HISTORIC AND DESIGN REVIEW COMMISSION

Agenda Item No: 19

HDRC CASE NO: 2016-239
ADDRESS: 3903 N ST MARYS
LEGAL DESCRIPTION:
ZONING: R6 HS RIO-1
CITY COUNCIL DIST.: 2
LANDMARK: Brackenridge Park
APPLICANT: Cosmo Guido/Guido Brothers Construction
OWNER: San Antonio Zoo
TYPE OF WORK: Renovations to Lion's Den Habitat
REQUEST:

MOAT TO BE FILLED

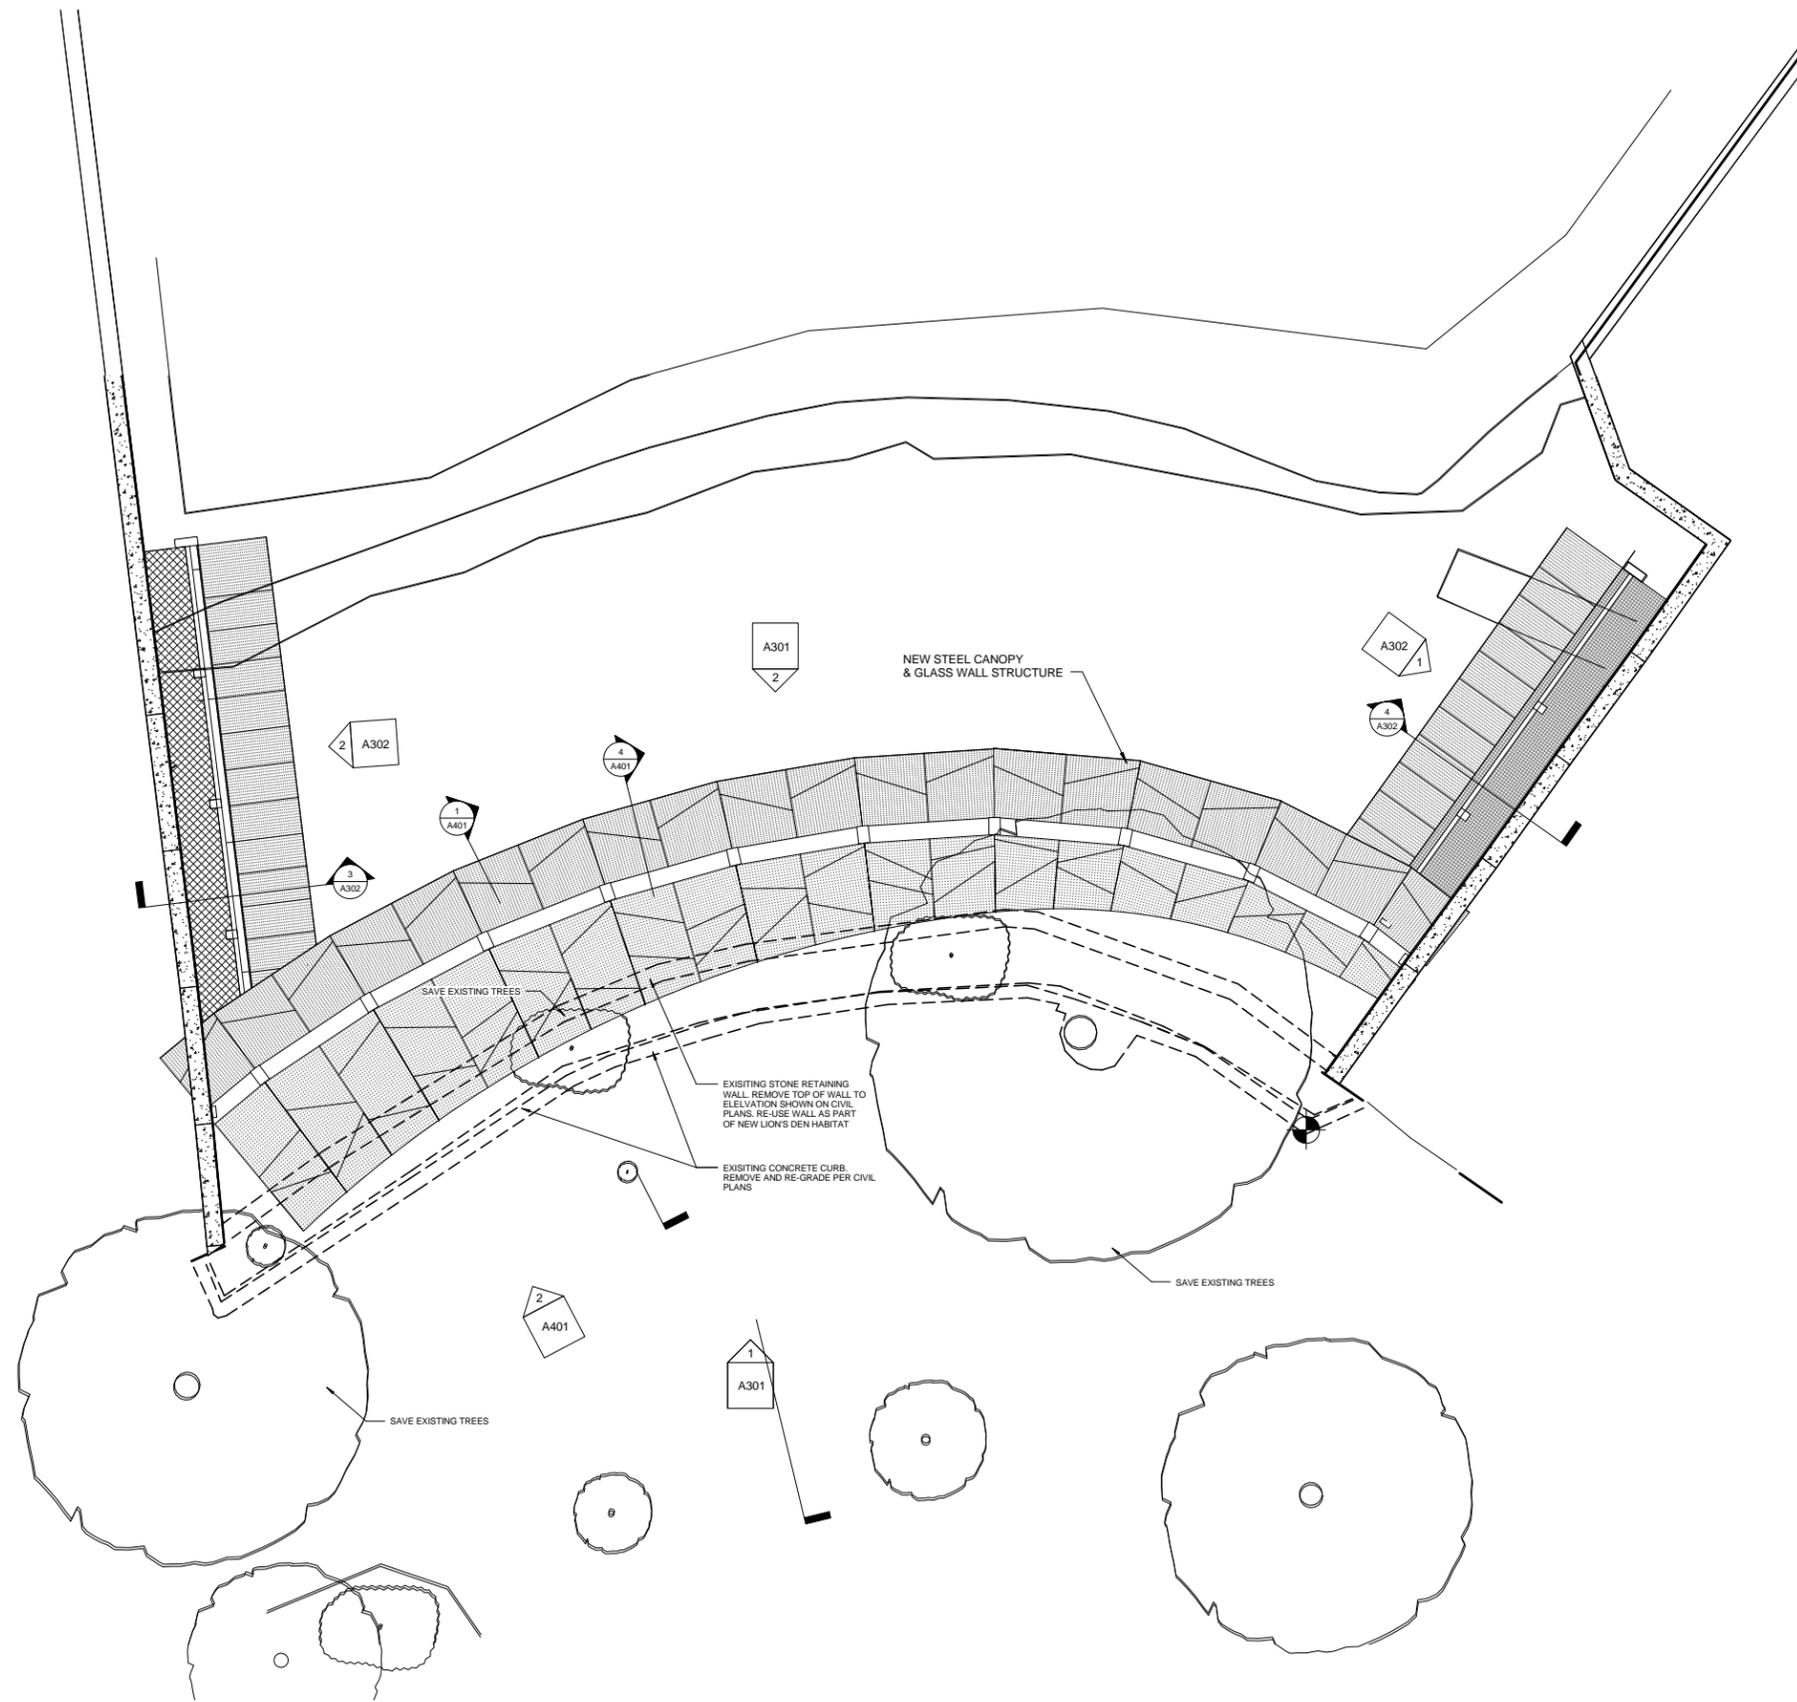
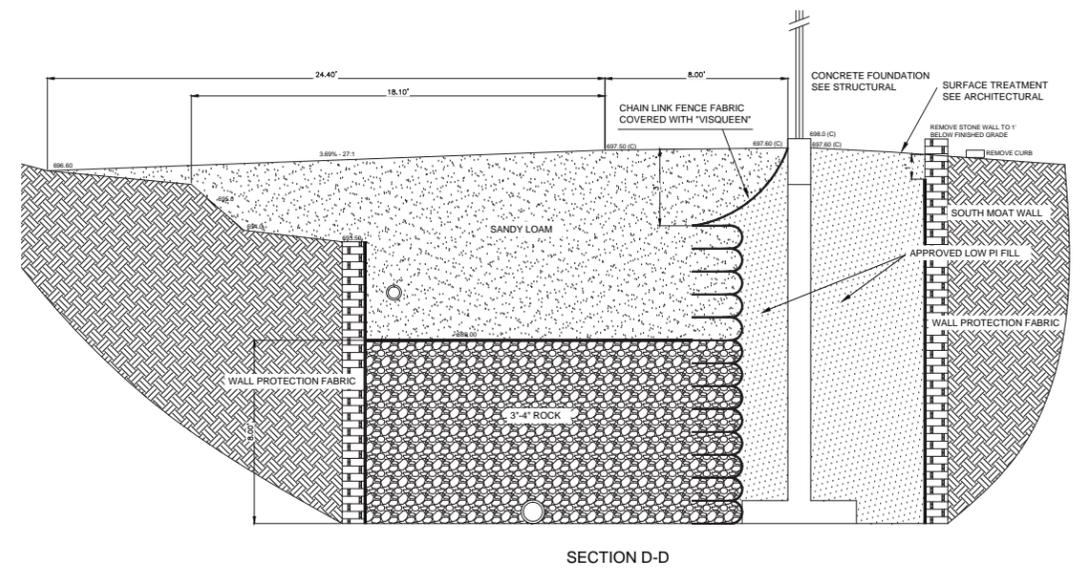
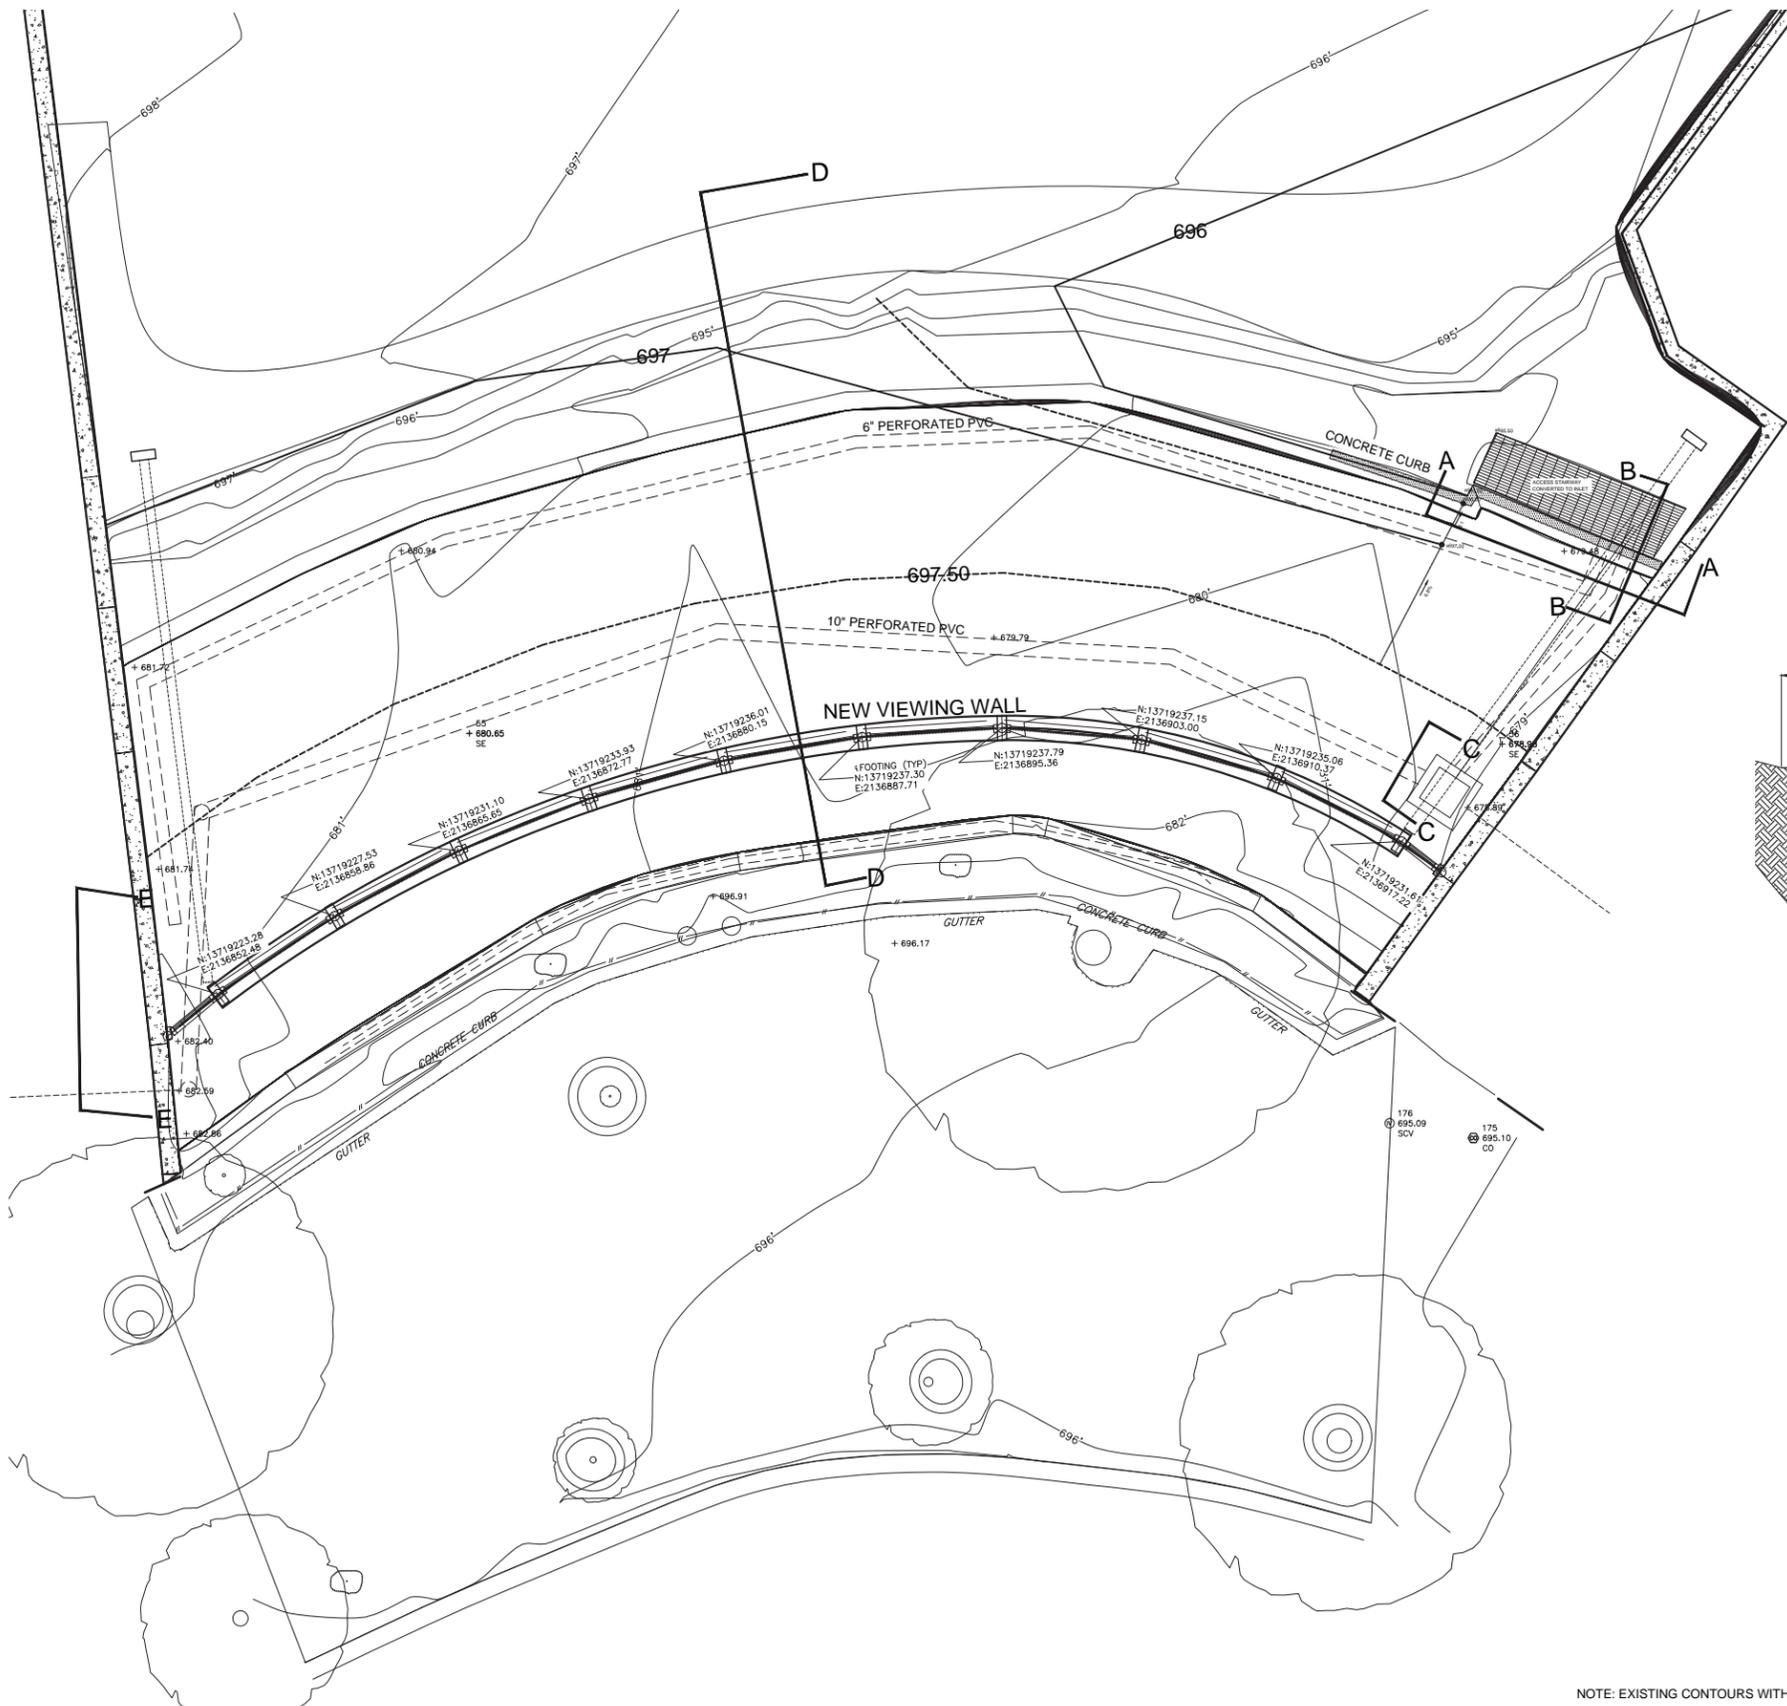
- a. The applicant has proposed to perform modifications and improvements to the existing lion's den habitat at the San Antonio Zoo. Within this request, the applicant has proposed to stabilize a WPA era wall by filling in an existing moat. The applicant has noted that the WPA era wall is failing and must be shored and buried to prevent future and further failure. With the filling in of the existing moat, the applicant has proposed to remove the top of the WPA era wall. Staff finds that the proposed scope of work is appropriate and necessary and recommends the applicant incorporate stone from the original wall into the new construction. Staff performed a site visit on June 23, 2016, where staff viewed damaged to the existing wall spoke with zoo personnel. Staff finds that original stone incorporated into the finished floor of the new viewing area or original stone incorporated as a veneer onto the base of the proposed new wall will allow visitors to interact with these historic elements.

Staff recommends approval with the stipulation that the original stone be incorporated into the finished floor of the new viewing area or original stone be incorporated as a veneer onto the base of the proposed new wall will allow visitors to interact with these historic elements.
